HF115F/HF115F-Q Product packaging change	Versions: 2
	PMI_20200707	Page 1 / of 3

Notice on packaging changes for HF115F/XX Family & HF115F-Q Family

HF115F Blister changes:

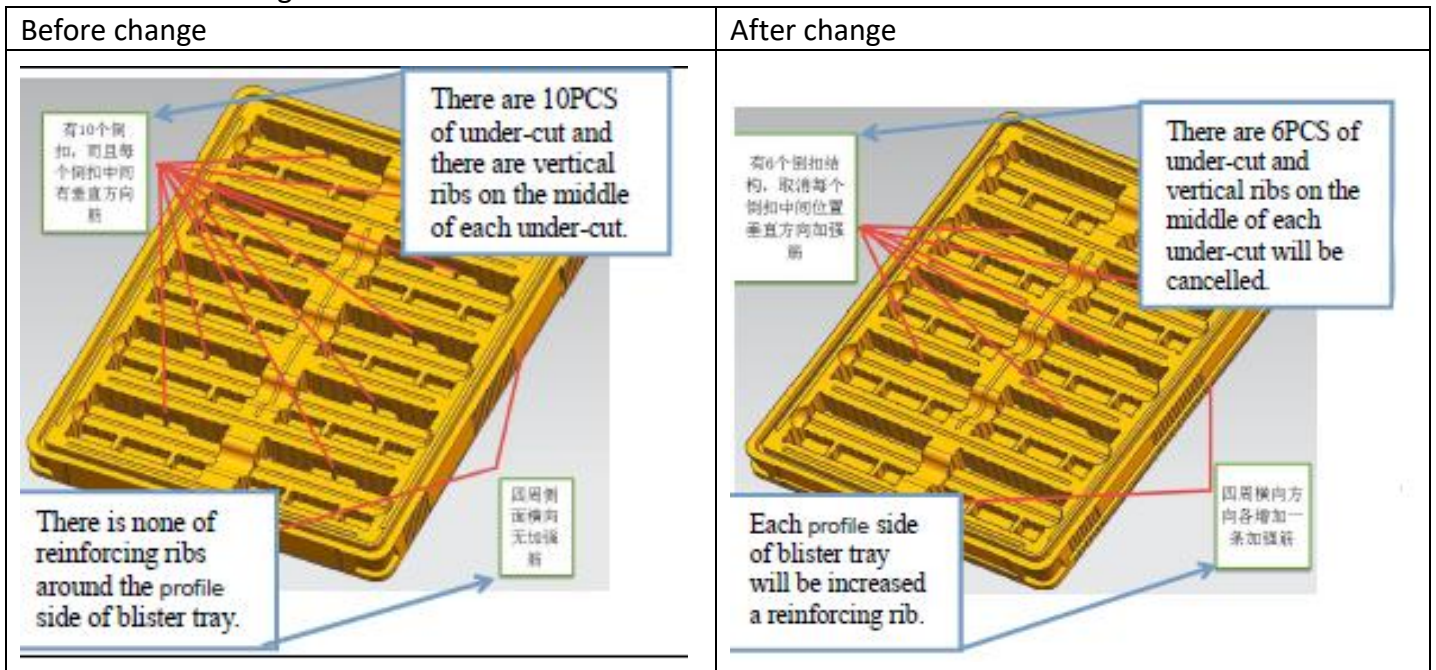
1. Change the structure of under-cut.
2. Increase horizontal reinforcing ribs around blister tray.

HF115FQ - Blister of HF115FQ with horizontal QC terminals

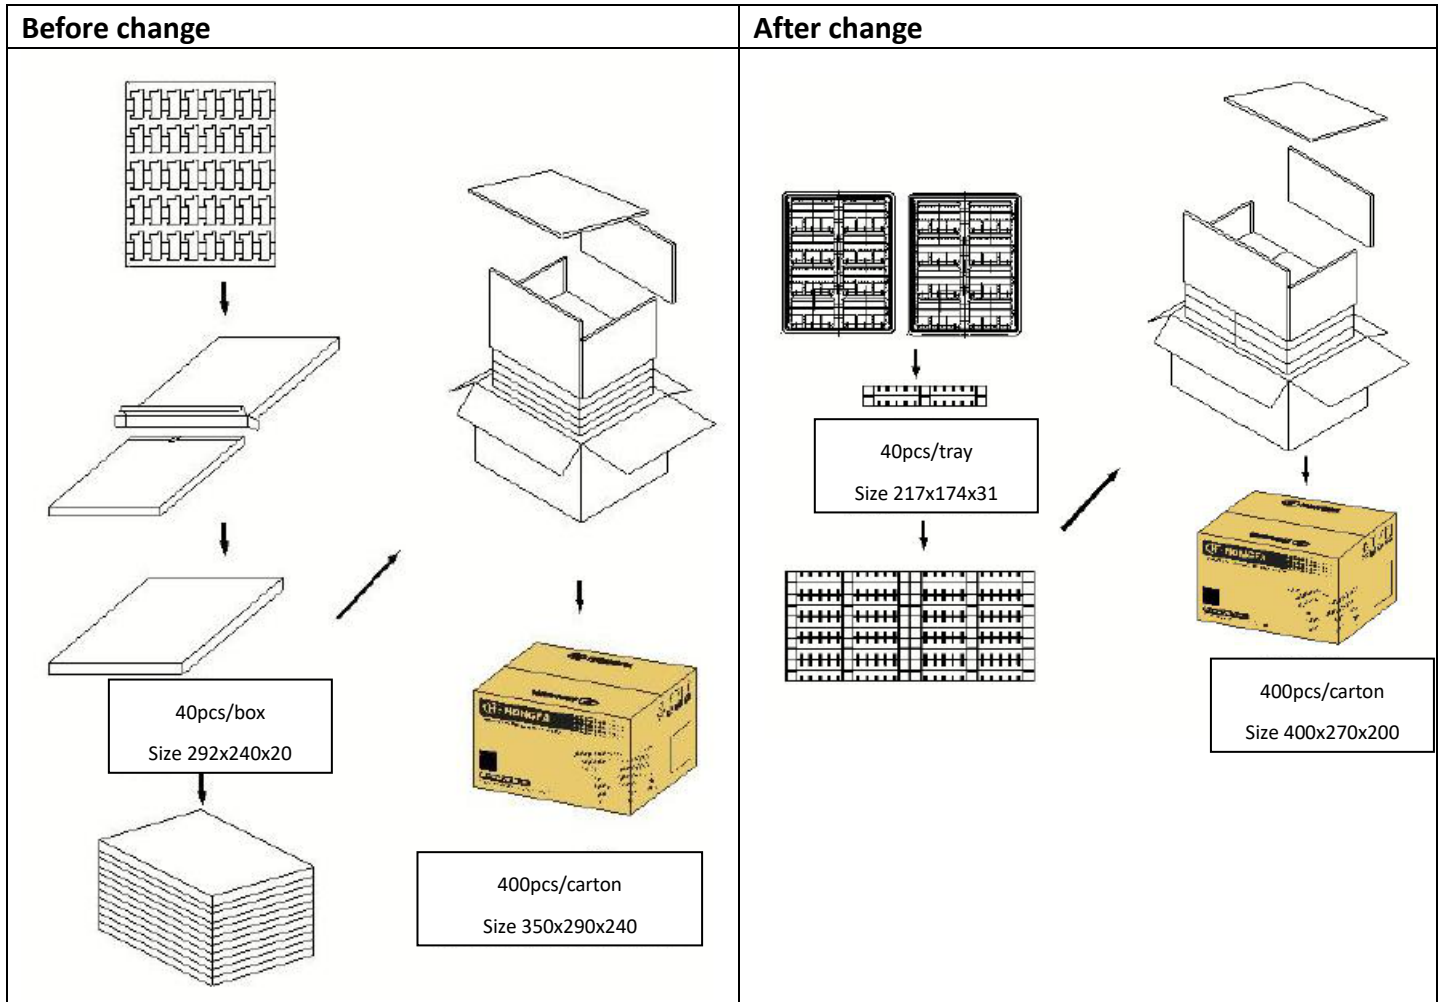
For the customer's convenience to take out the relay from the plastic tray, HF115F-Q horizontal type consists of a plastic tray + plastic bag. The packaging of the carton is changed to the packaging of the upper and lower plastic trays to the cover (same as HF115F-Q vertical). Number of packages.

The quantity remains unchanged, the outer box size, and the plastic tray size changes as shown in the above figure.

Blister tray of HF115FQ with vertical QC terminals:

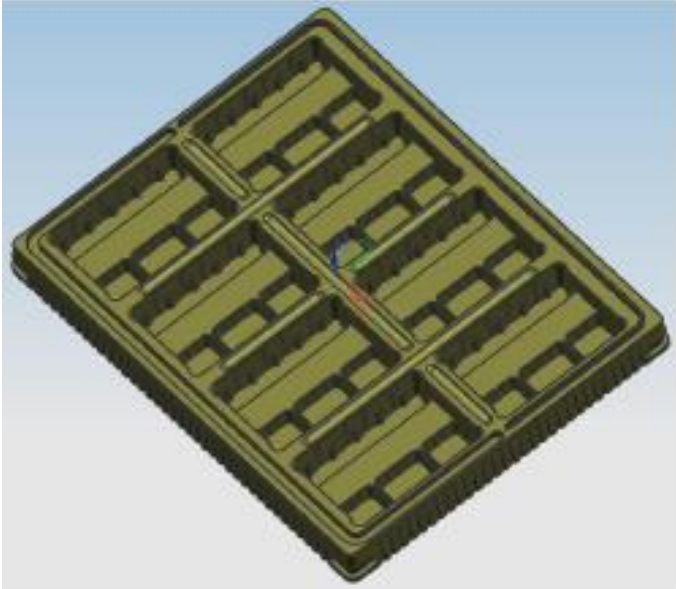
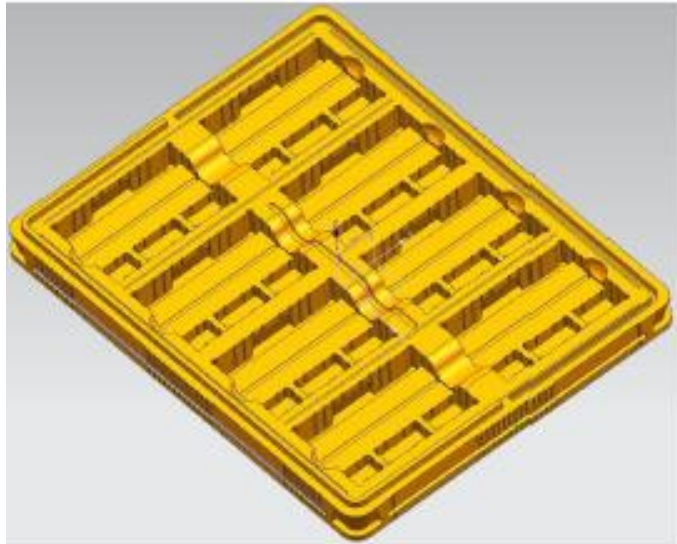
To remove the relay easily from the plastic tray, the HF115F-Q vertical plastic tray structure is fine-tuned. The external dimensions remain unchanged and the number of packages remains unchanged.
